ADDENDUM 3

ADDENDUM DATE: October 17th, 2024

PROJECT: Orange County Architectural Renovations
Orange County, NC

ARCHITECT: Smith Sinnett Architecture, P.A.
4600 Lake Boone Trail, Suite 205
Raleigh, North Carolina 27607

DRAWN BY: AH
CHECKED BY: DW
WINDOW & CORNICE DETAILS

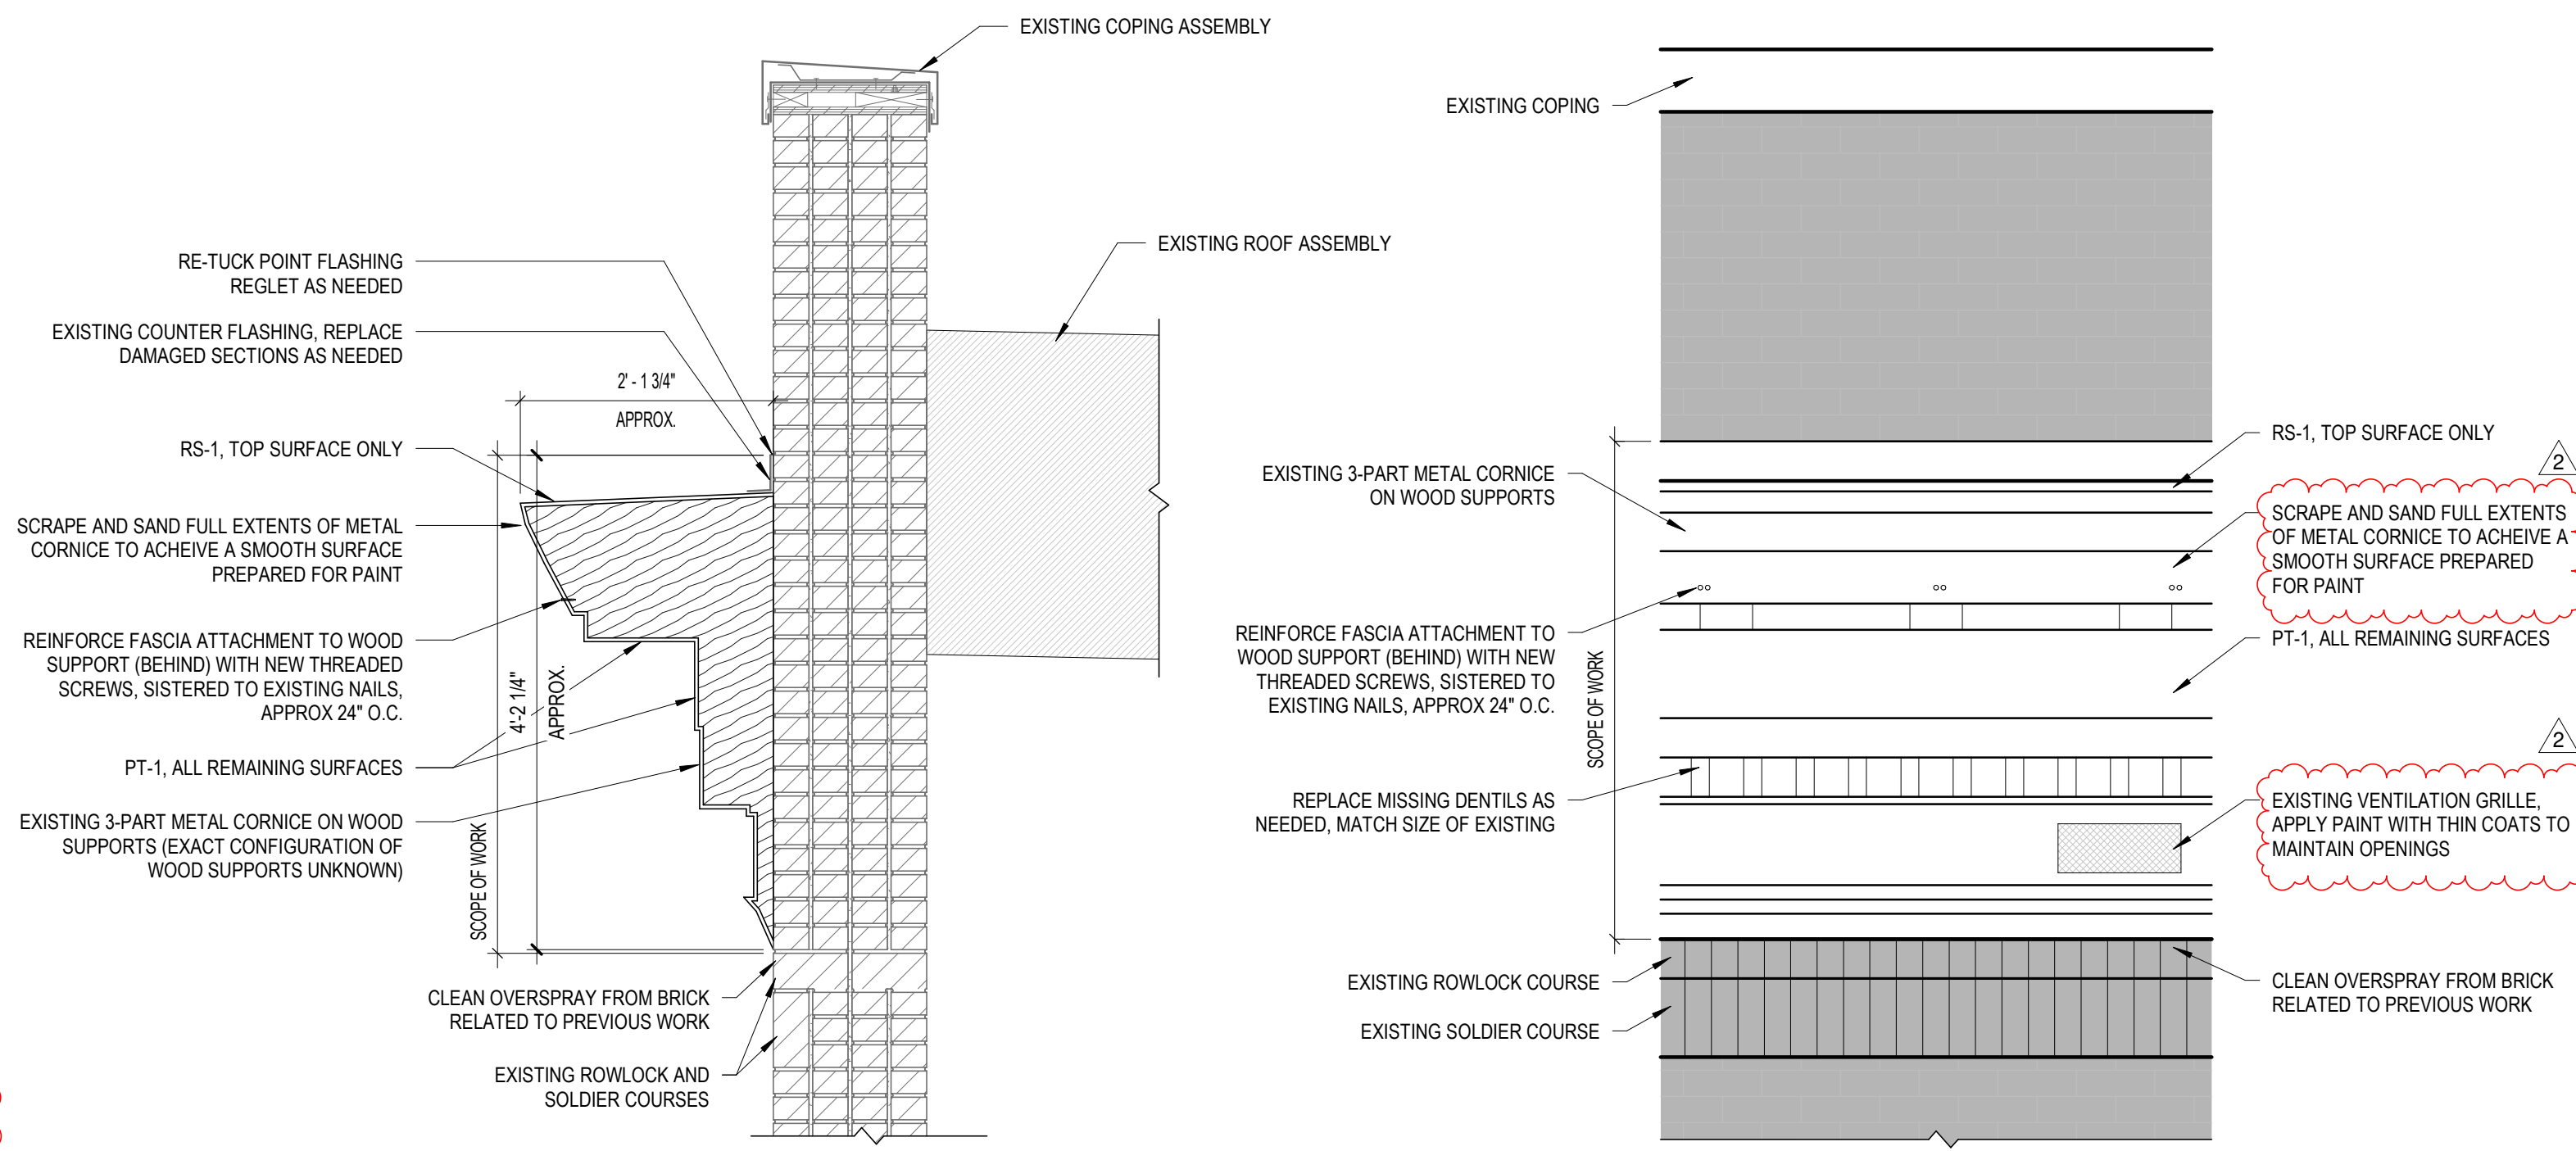
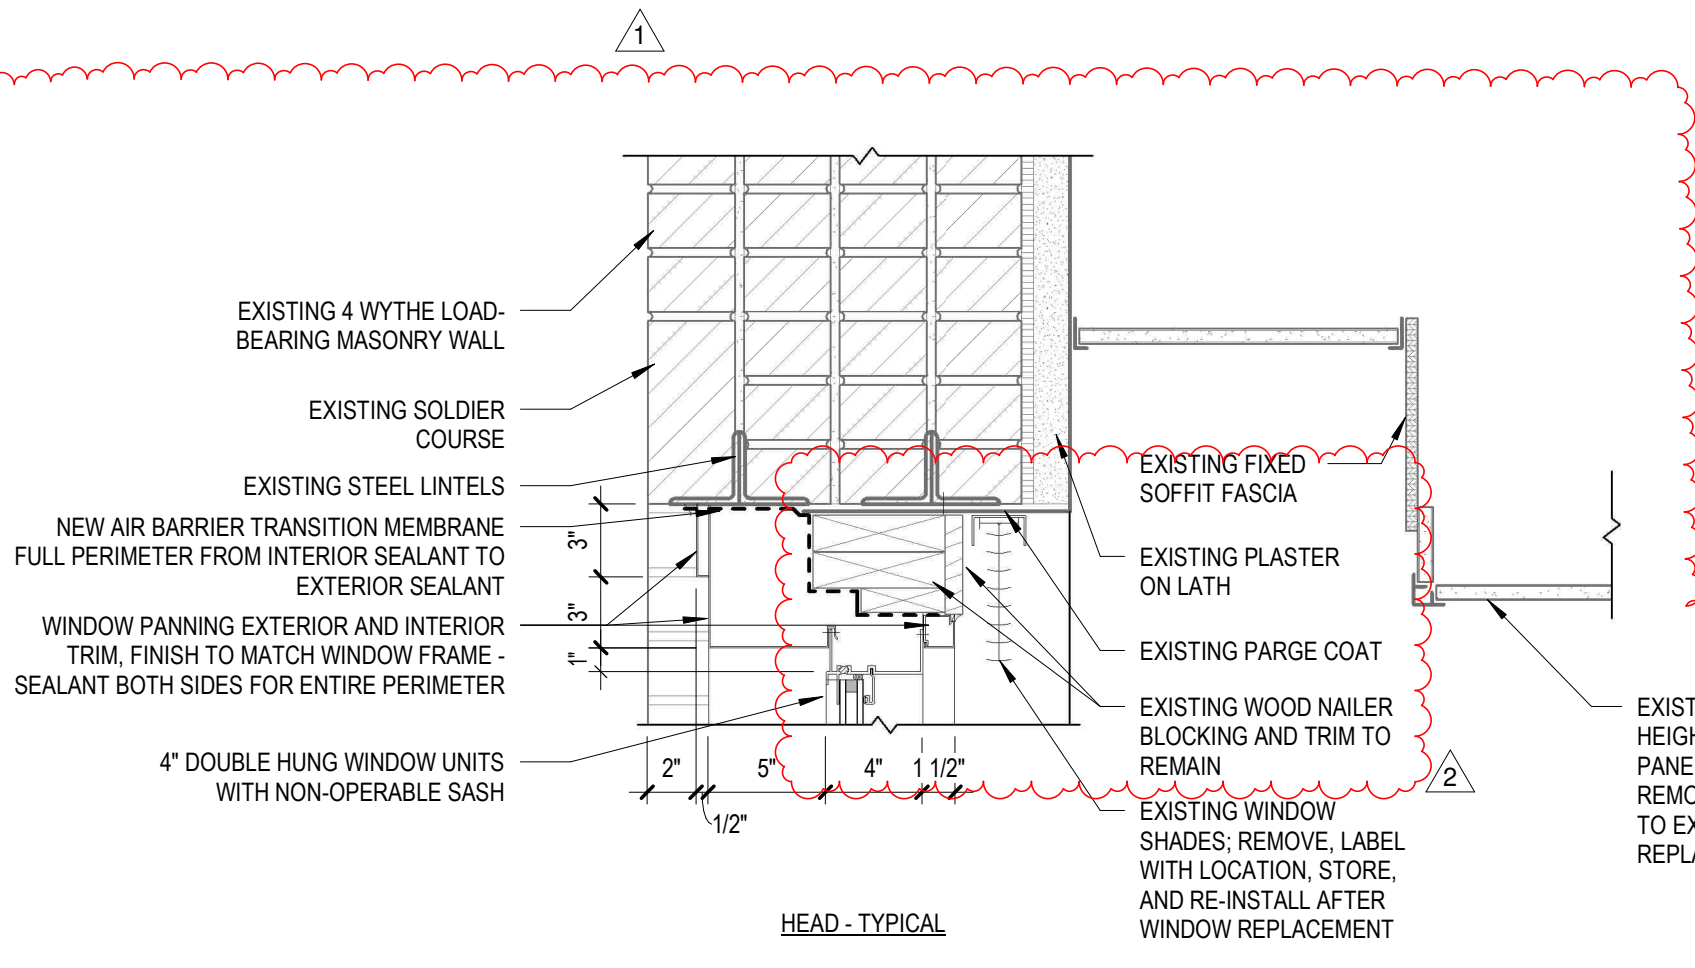
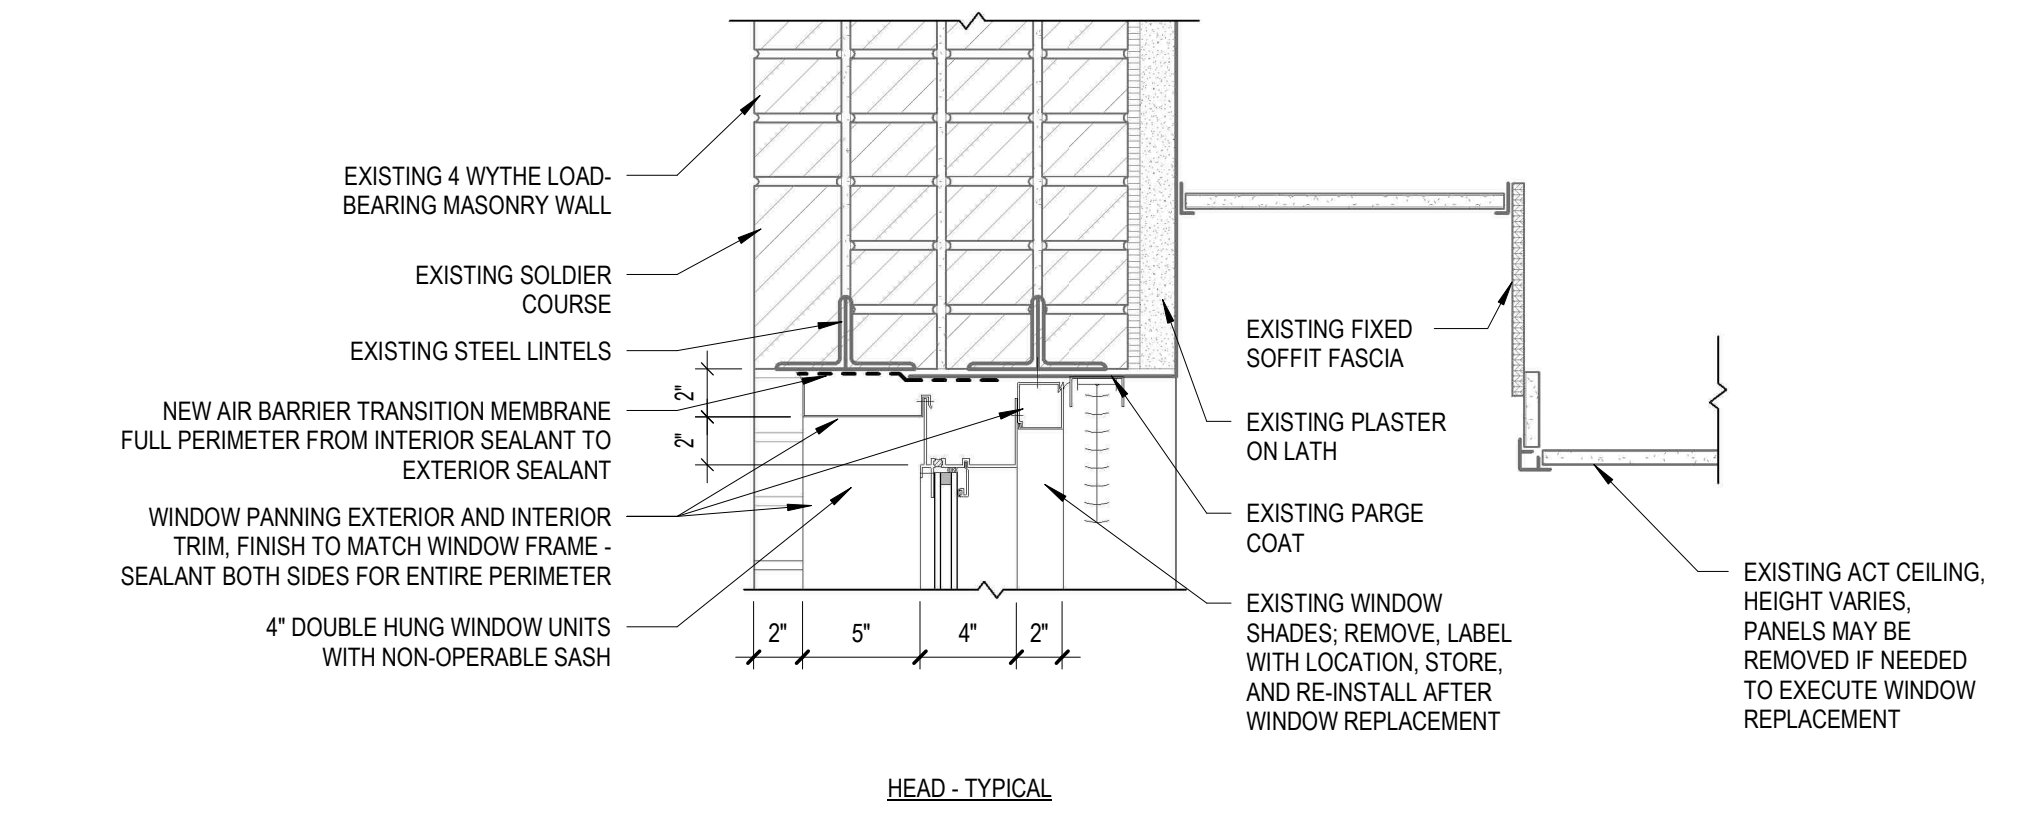
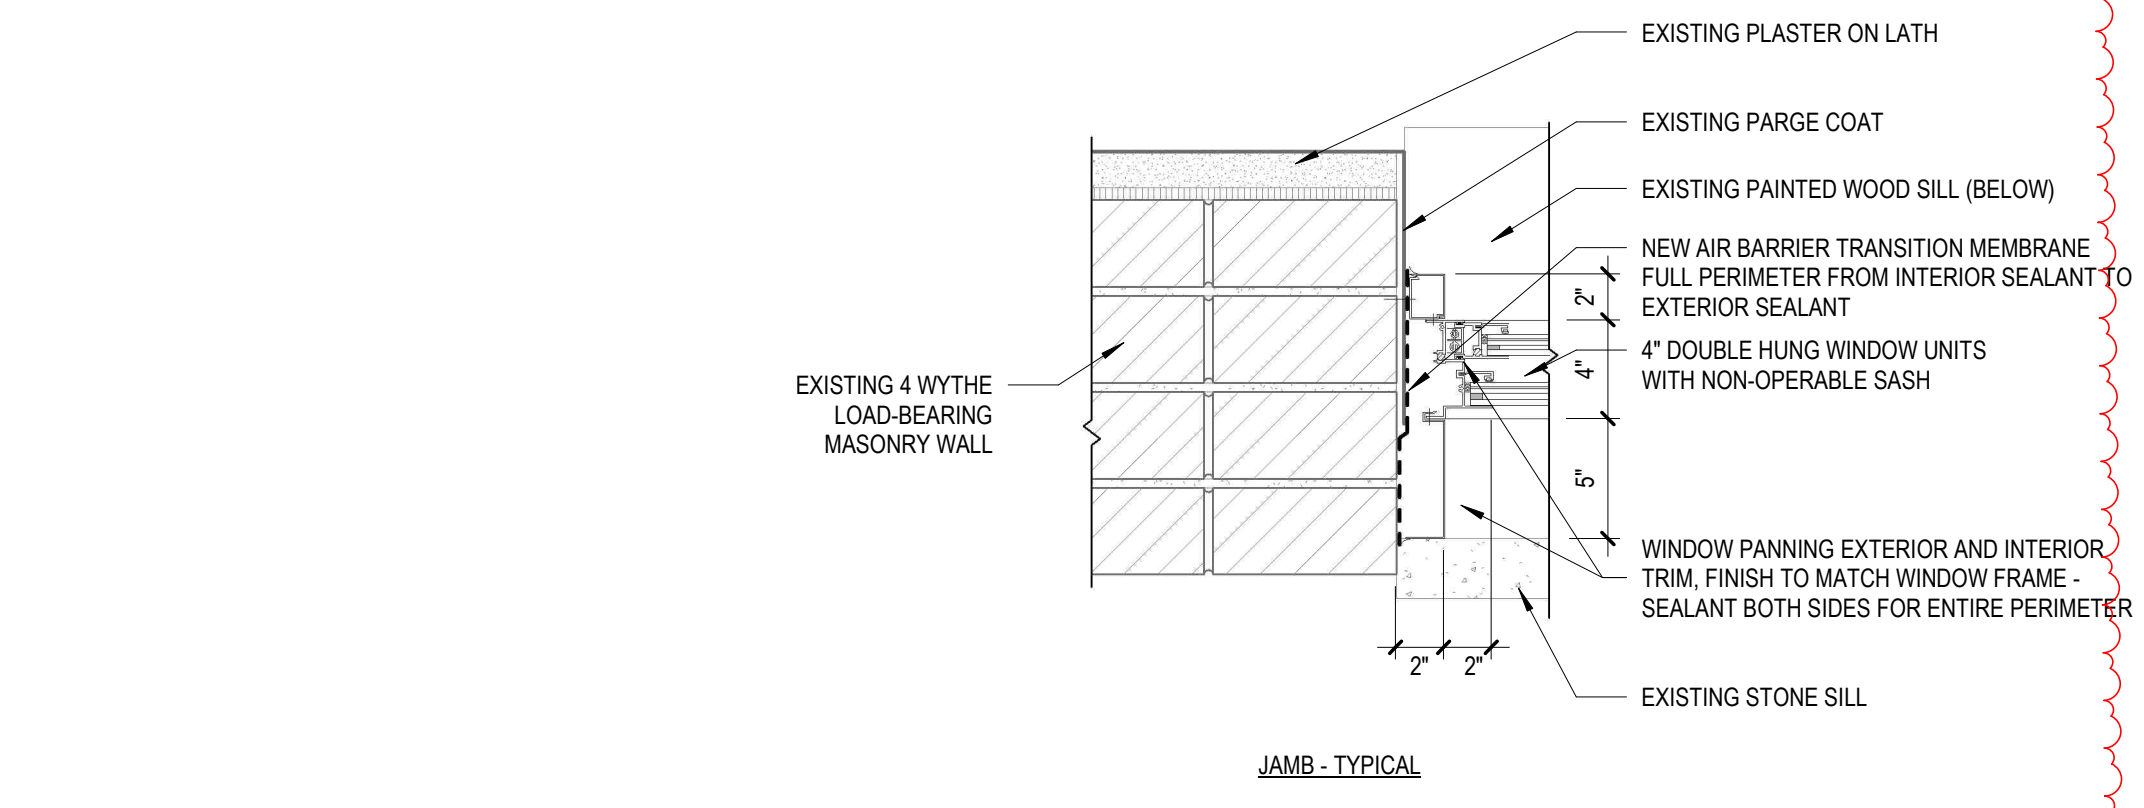
- d. **Revised:** A6-12 – Details Revised to show existing interior frame more accurately with trim and wood nailer blocking to remain. Interior snap trim and exterior panning at full perimeter as shown. Provide necessary connector panning for multi-window assemblies. Cornice details and notes have been revised. Sandblasting is no longer required for prepping cornice for paint.
